# Development: Cross Green Lane Leeds Road Safety Audit: Stage 1/2

Report Produced for: Report Produced by: Report Dated: Report Reference: Road Safety Audit Team Leader: Lees City Council Jonathan Birkett 05 April 2024 MAL/CGLLRSA12Rev0 Jonathan Birkett

## Road Safety Audit: Stage 1/2

#### 2.2 Problem Location Plan

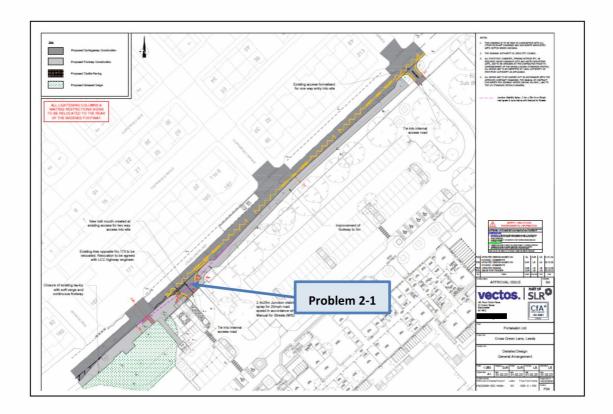
PROBLEM		
Location:	Site access.	
Summary:	mary: Tactile paving that does not meet the required standards will increase the risk of Visually Impaired User/vehicle collisions.

The drawings show that a new uncontrolled in-line crossing will be constructed across the access junction. DfT standards require that the minimum depth of tactile paving across an in-line crossing must be 1200mm. This is not the case. Tactile paving that does not meet the required standards will increase the risk of Visually Impaired User/vehicle collisions.

Ensure that the minimum depth of tactile paving is 1200mm across the whole width of the crossing (three tactile paving slabs minimum).
